Access Compliance Report

Public Rights-of-Way

Intersection ID: 31569	Main Street: ARVIN_DR	Cross Street: CROSS_ST	Location:	N
ADA ID: F4557614306C	Ramp Type: Combination1	Initial Pass/Fail: Fail	Overall Compliance: No	Severity Score: 10
Codes/Mitigation Info/Possible Solution		Field Measurements/Component Compliance

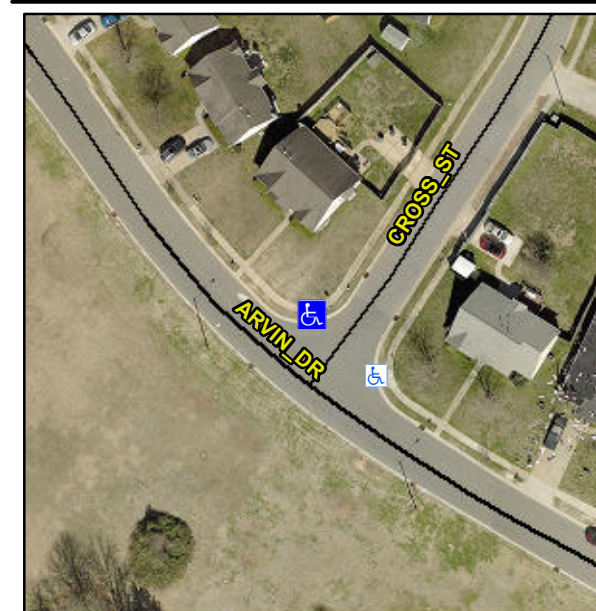
RT RP < 5%

Not Found, R304.5.1, R304.5.3

Remove & Replace Entire Ramp.
